PLANNING UNIT REPORT
DEPARTMENT OF PLANNING AND DEVELOPMENT
December 29, 2005

**ZONING MAP AMENDMENT, I.D. 02455 TO REZONE 33 SOUTH BROOM STREET
FROM UNRECORDED PUD-SIP TO AMENDED PUD-GDP-SIP:**

SUBJECT: **33 South Broom Street – Rezoning – Unrecorded PUD (SIP) to Amended PUD (GDP-SIP) – 23 Condominium Units**

SUBJECT: 33 South Broom Street (15 S. Broom Street) PUD (GDP/SIP)

Atch. Portion of submission page C 102 "Layout Plan" [10/26/2005]

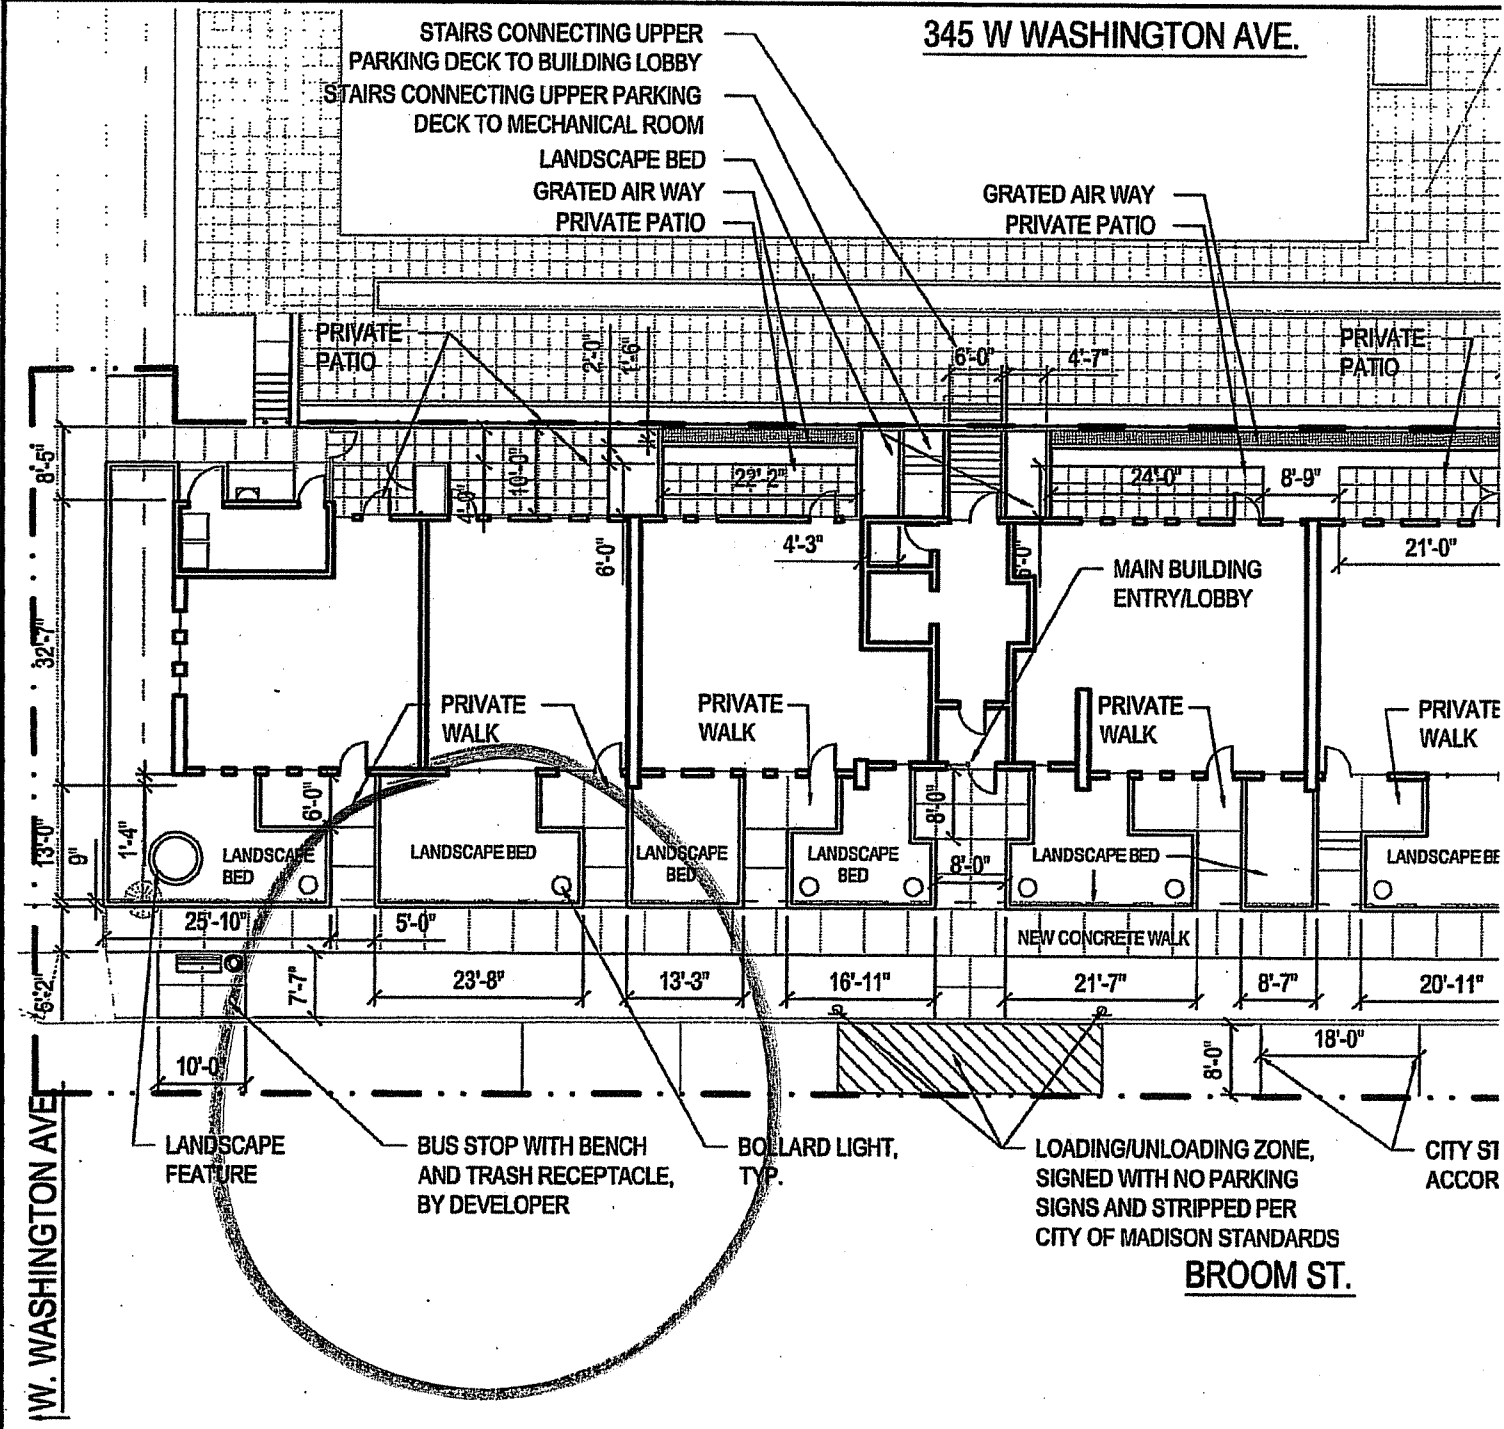
Metro Transit initiated this comment during a pre-submission meeting with the applicant, and presented this condition as part of the application for the rezoning of 309 West Washington Avenue. The current landscape plan submitted by the applicant shows just a bench with trash receptacle on City right-of-way between the curb and sidewalk. The current landscape plan further shows the bench and trash receptacle blocking the access zone requirement.

6. The PUD/SIP submitted with this rezoning, and dated October 26 2005, does show the placement of a "new bus shelter" at the bus stop identified above. However, it does point to placing it in the City right-of-way.

3. Such passenger amenity requests are typically fulfilled with the applicant installing the items on private property behind the sidewalk. It is Metro Transit's recommendation that the applicant continue to review the potential of placing the amenities outlined above on private property. **Placement of privately installed and maintained property on City right-of-way will require the review and approval of additional City agencies, including City Real Estate and City Engineering, prior to Metro Transit giving final approval to the plans.**
4. The developer shall include this concrete passenger boarding pad, shelter with bench, and trash receptacle on the final documents filed with their permit application so that Metro Transit may review and approve the design.
